Addendum No: 02

Project: Davis Elementary School, LUSD

Issue Date: 08/04/2026

PBK Project No: 230217 / DSA # 02-123250

5 ELECTRICAL FLOOR PLAN - BUILDING 'I'
SCALE: 1/8" = 1'-0"

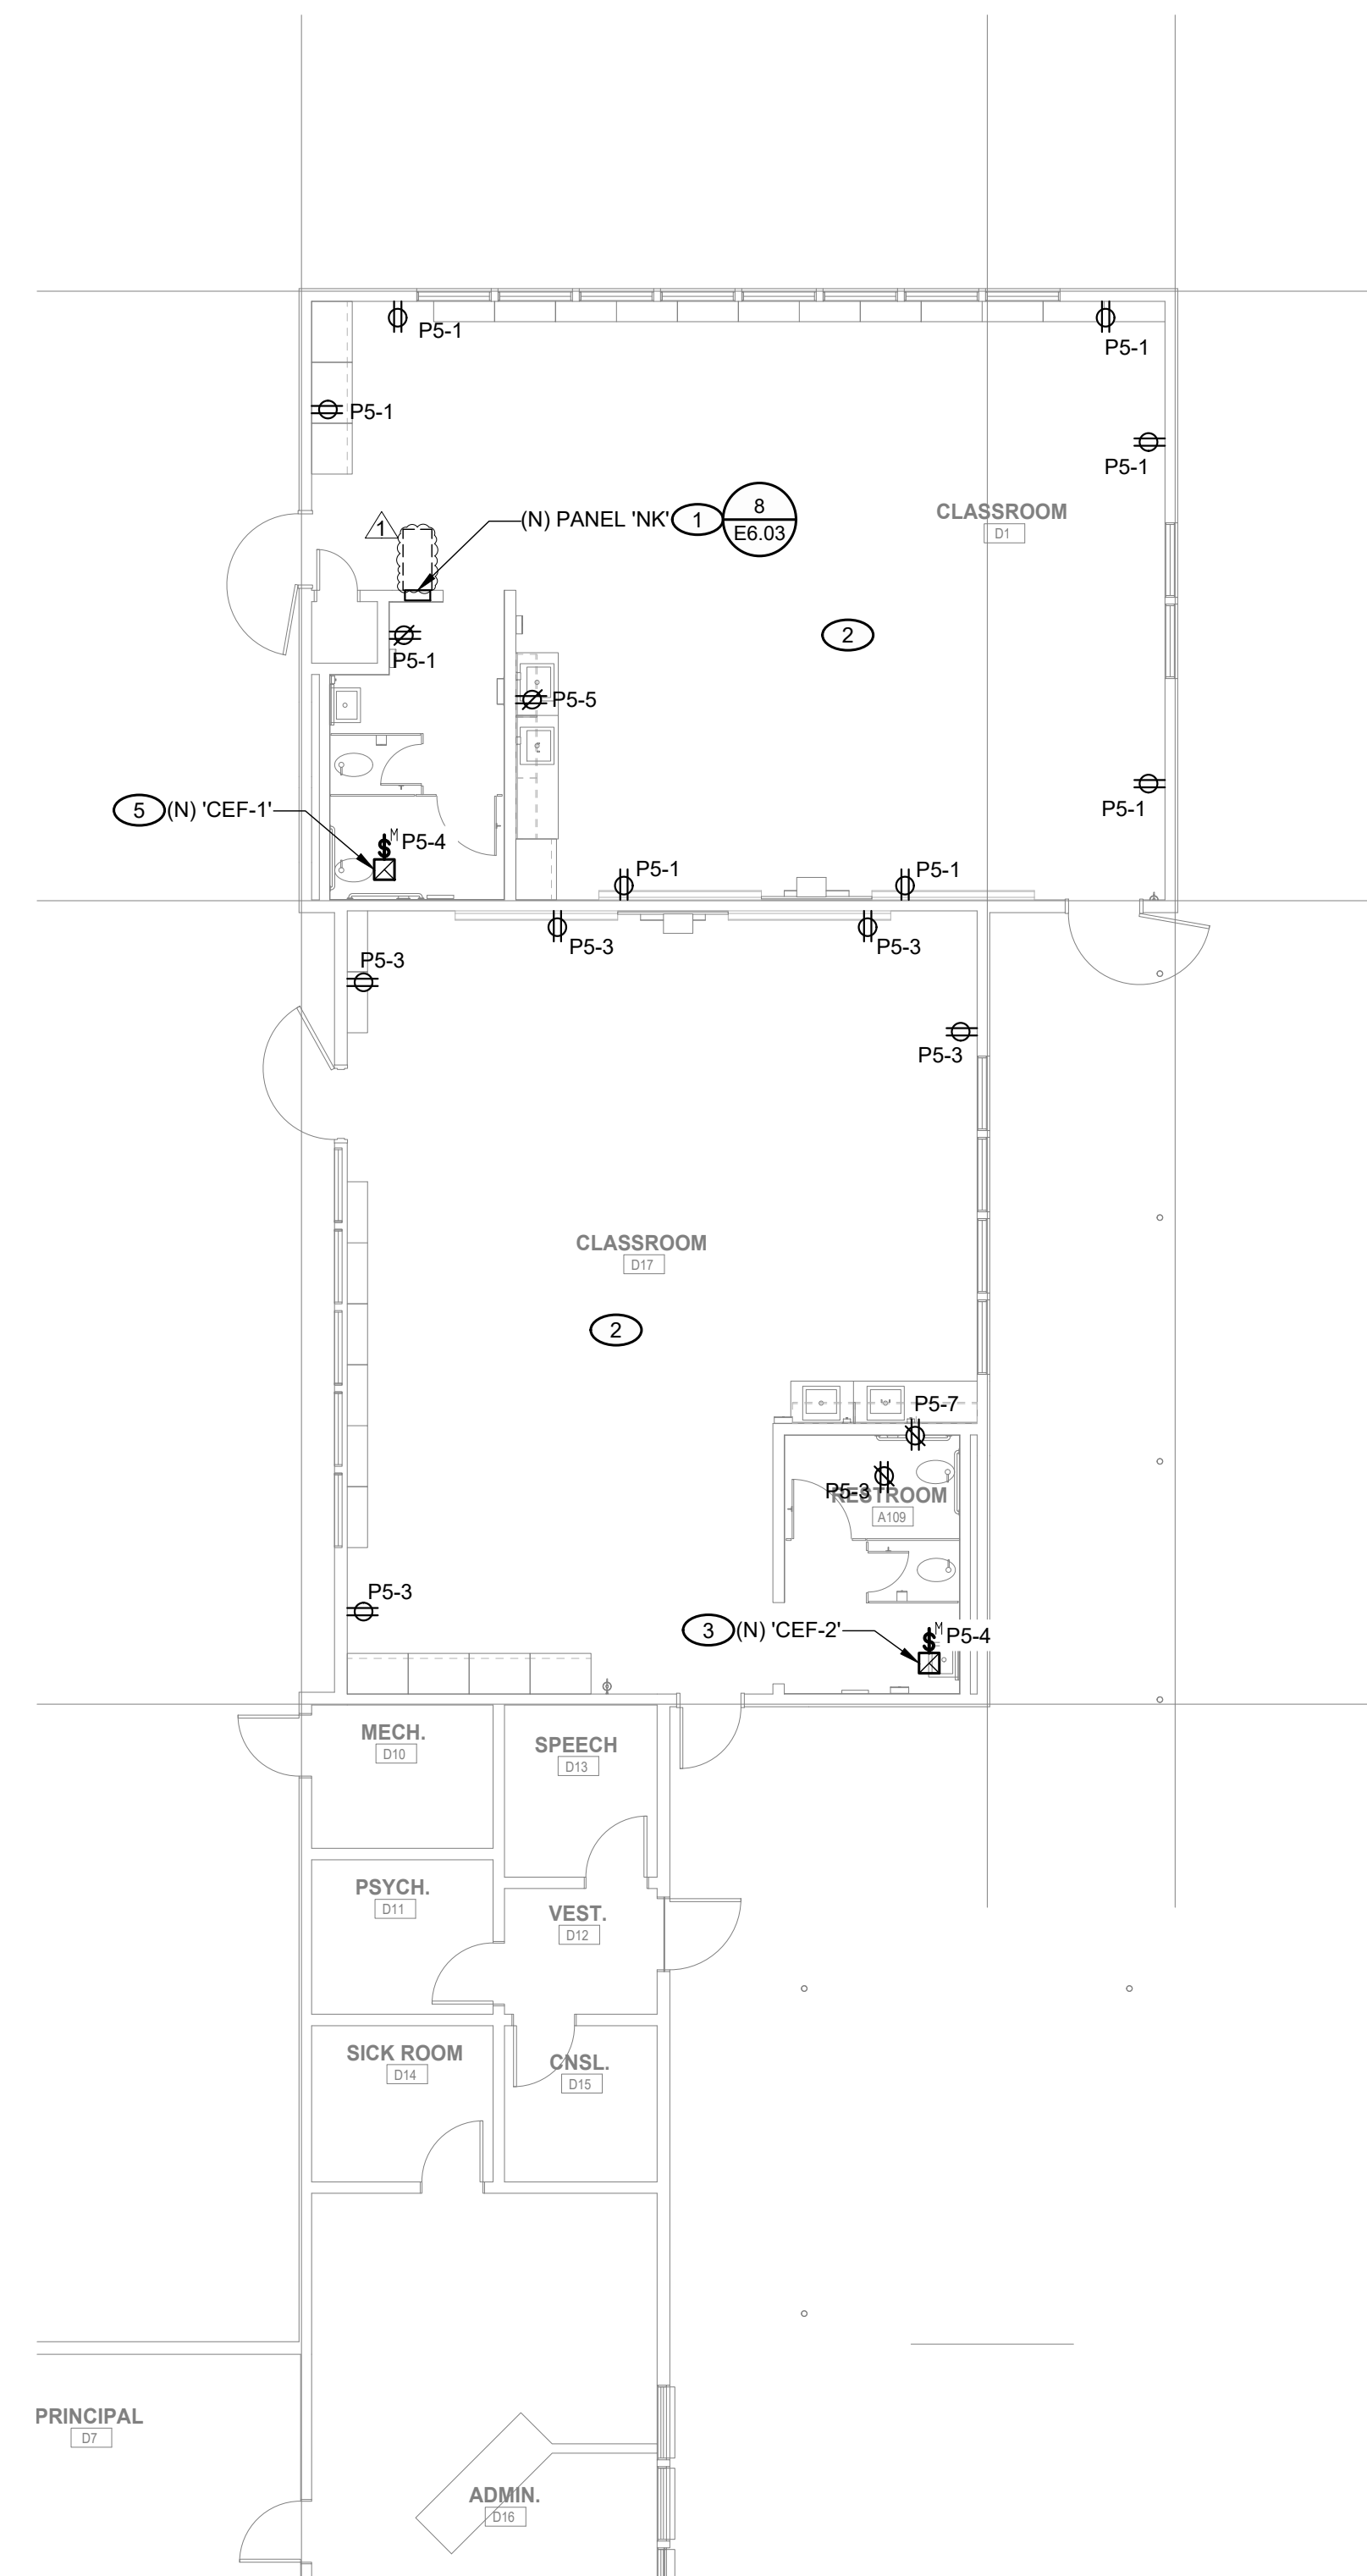
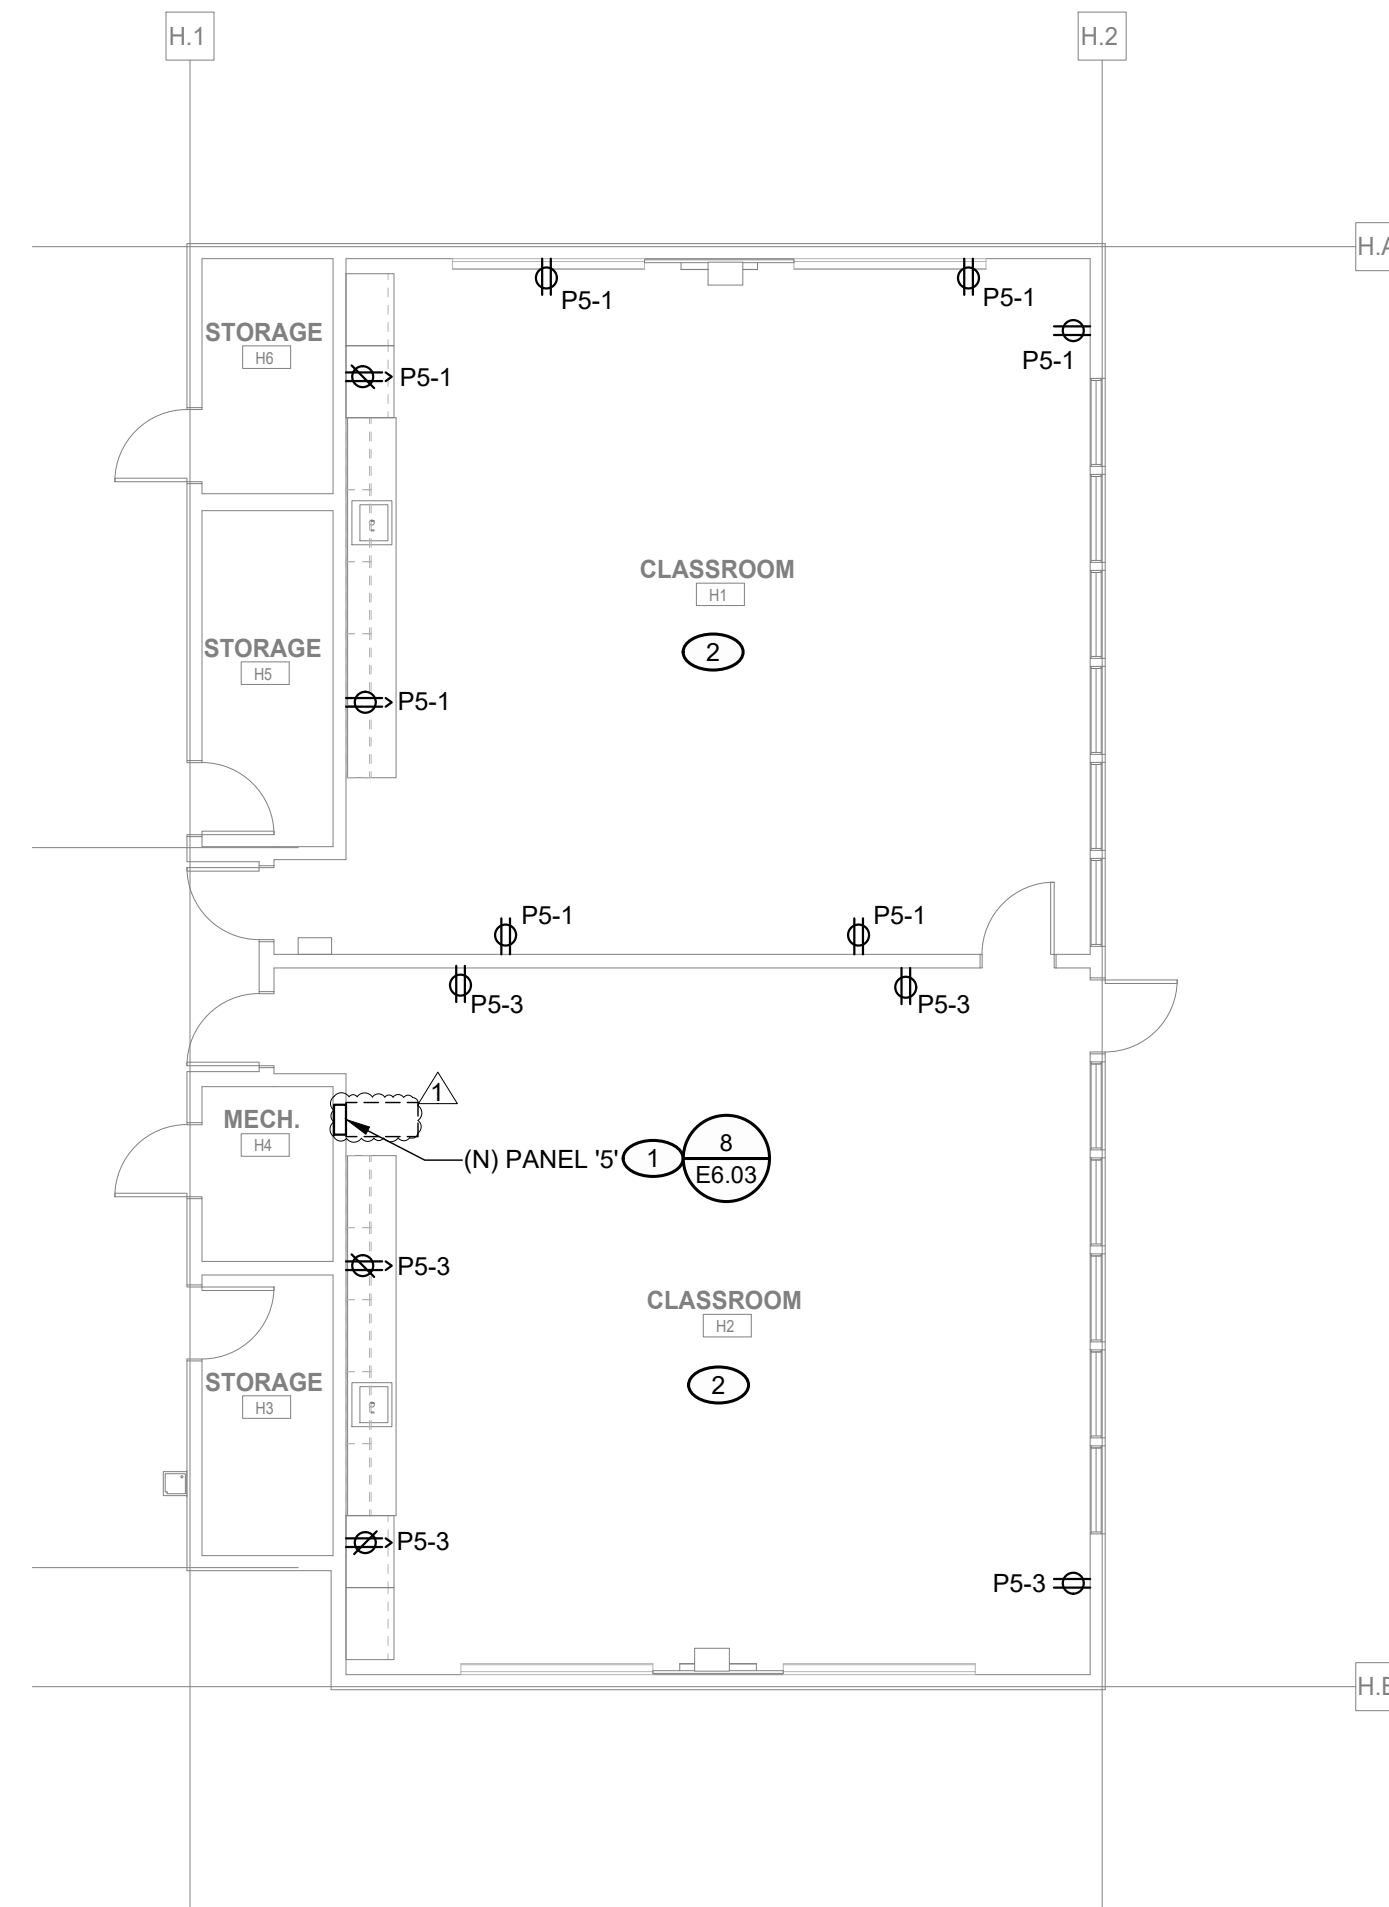
- Item 14. Replace sheet E2.01 – Electrical Floor Plan with the attached sheet showing a new panel in Building H and updated Key Note #1 and General Note #1.

1. PROVIDE NEW 100A LOADCENTER, RECONNECT EXISTING FEEDER CONDUCTORS AND CONDUITS FROM DEMOLISHED PANEL'S ORIGINAL LOCATION AND EXTEND AS NECESSARY TO NEW PANEL LOCATION. SEE KEYNOTE #1 SHEET 'E2.01' FOR ORIGINAL PANEL'S LOCATION.
2. PROVIDE NEW POWER RECEPTACLES IN CLASSROOM. ALL DEVICES SHOWN ARE NEW AND ARE TO BE PROVIDED BY THE ELECTRICAL CONTRACTOR.
3. PROVIDE POWER TO NEW ROOFTOP EXHAUST FAN FOR BATHROOM.
4. PROVIDE DEDICATED QUADPLEX NEMA 5-20 RECEPTACLE AND A DEDICATED NEMA L6-30 RECEPTACLE FOR IDF. COORDINATE LOCATION AND MOUNTING HEIGHT WITH TECHNOLOGY CONTRACTOR PRIOR TO INSTALLATION.
5. PROVIDE POWER TO NEW CEILING EXHAUST FAN FOR BATHROOM.
6. PROVIDE 208V, 1Ø POWER TO NEW INSTANT WATER HEATER.

1. ELECTRICAL PANELBOARDS AND LOADCENTERS INSTALLED IN PUBLIC (UNRESTRICTED) AREAS ARE TO BE SPECIFIED AND PROVIDED WITH LOCKABLE COVERS.

1 SINGLE LINE DIAGRAM - DEMO
SCALE: NTS

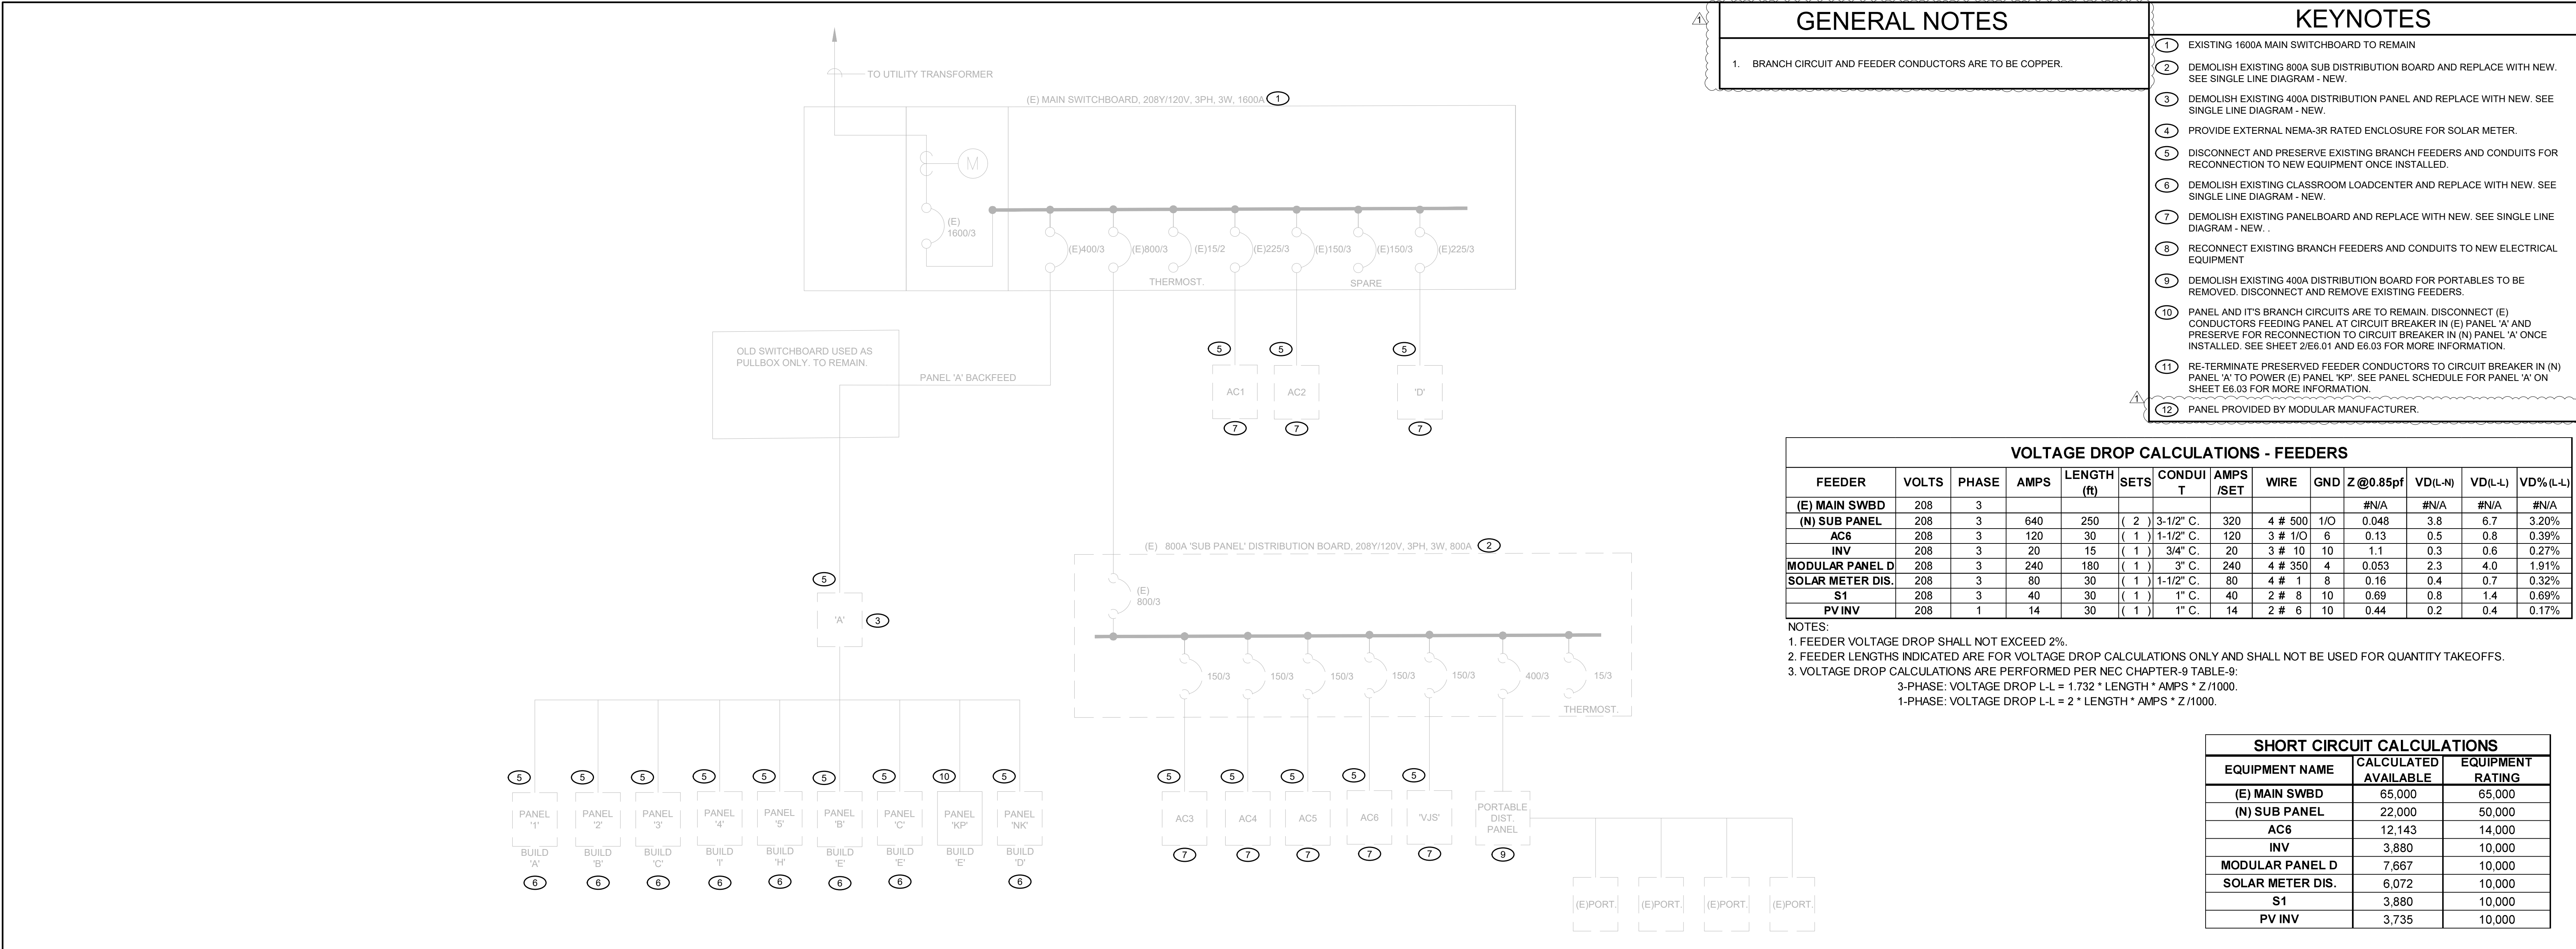
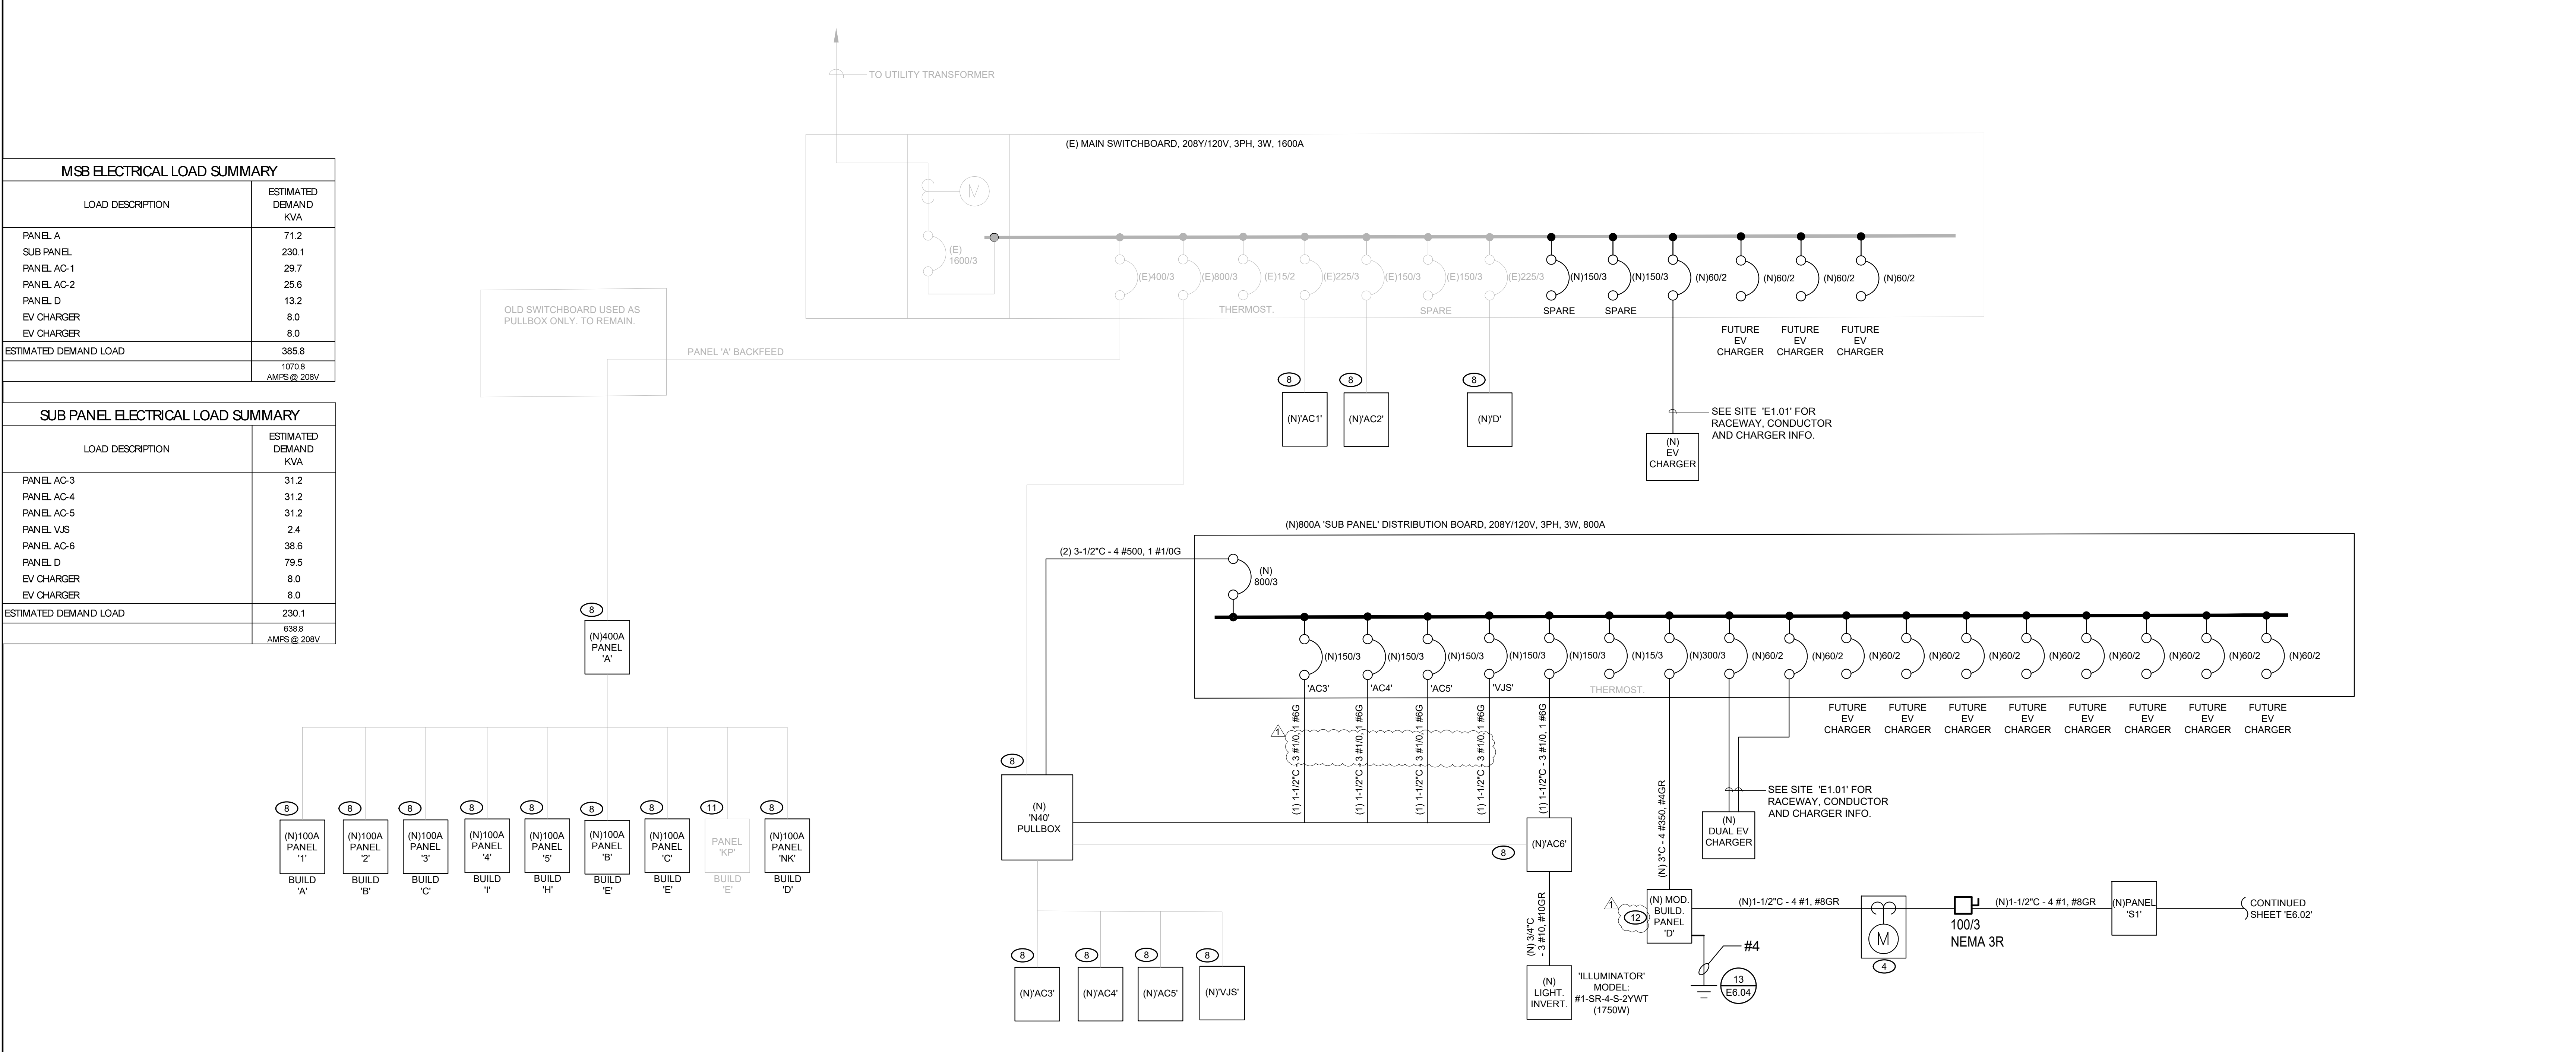
- Item 15. Replace sheet E6.01 – Electrical One Line with the attached sheet showing a new panel in Building D and updated Key Note #1 and General Note #1.
